# Progress on Industry Guidance for Phase 2 NEI 13-02 Rev 1 Draft

NRC Public Meeting  
November 20, 2014

## C.2.2.2

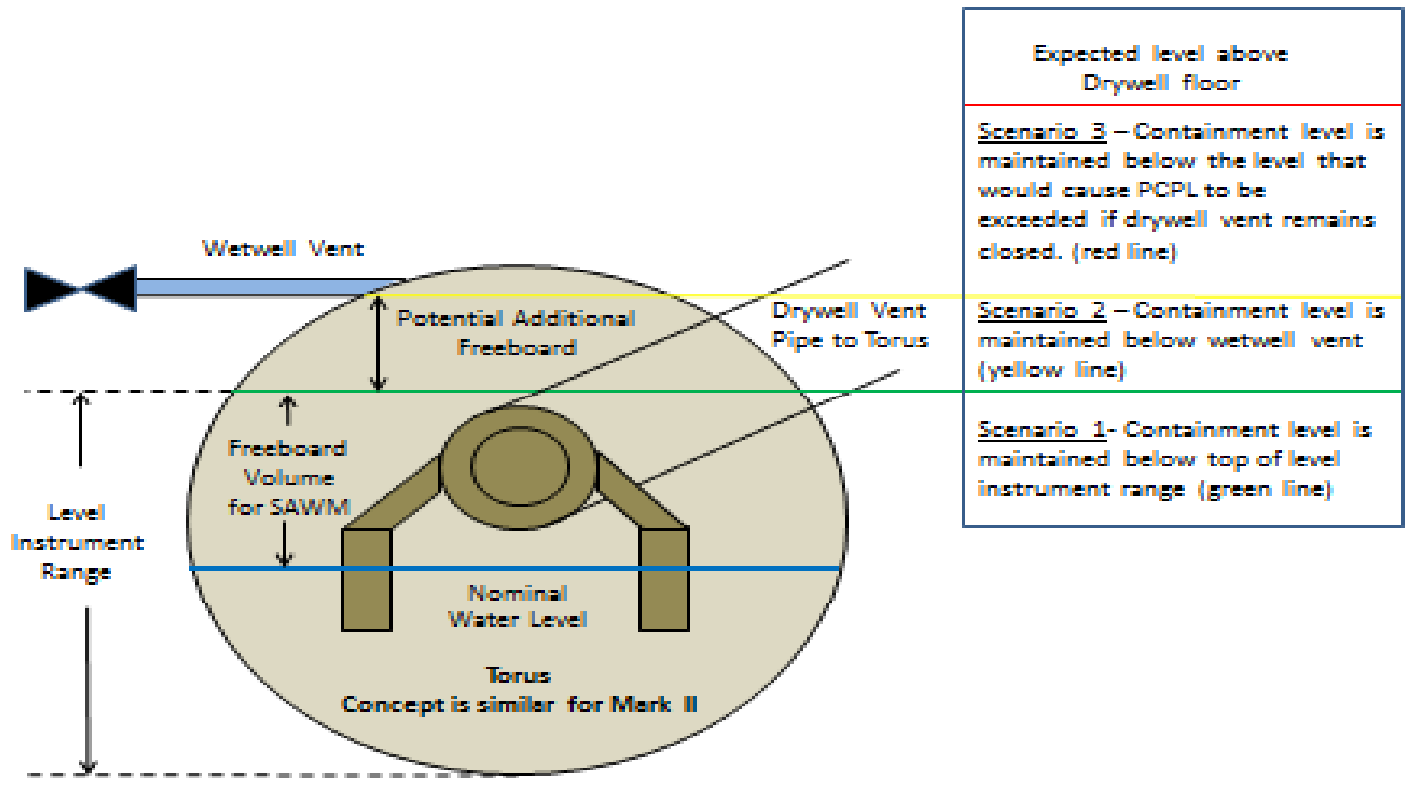
- Length of time that the wetwell vent path is to be preserved (e.g., ~~48~~**72** hours).
  - To transition to the alternate reliable containment heat removal and pressure control conditions sites may utilize a combination of installed and portable equipment.

- This section provides the rationale for establishing ~~48~~**72** hours as a reasonable length of time for **preserving the wetwell vent path for Severe Accident Coping. Licensees that can demonstrate transition from Severe Accident Coping to alternate containment heat removal that does not require the use of a drywell vent may propose a shorter wetwell preservation time with supporting documentation in the Phase 2 OIP.** Decay heat is significantly reduced within the first hours of the event (SOARCA),
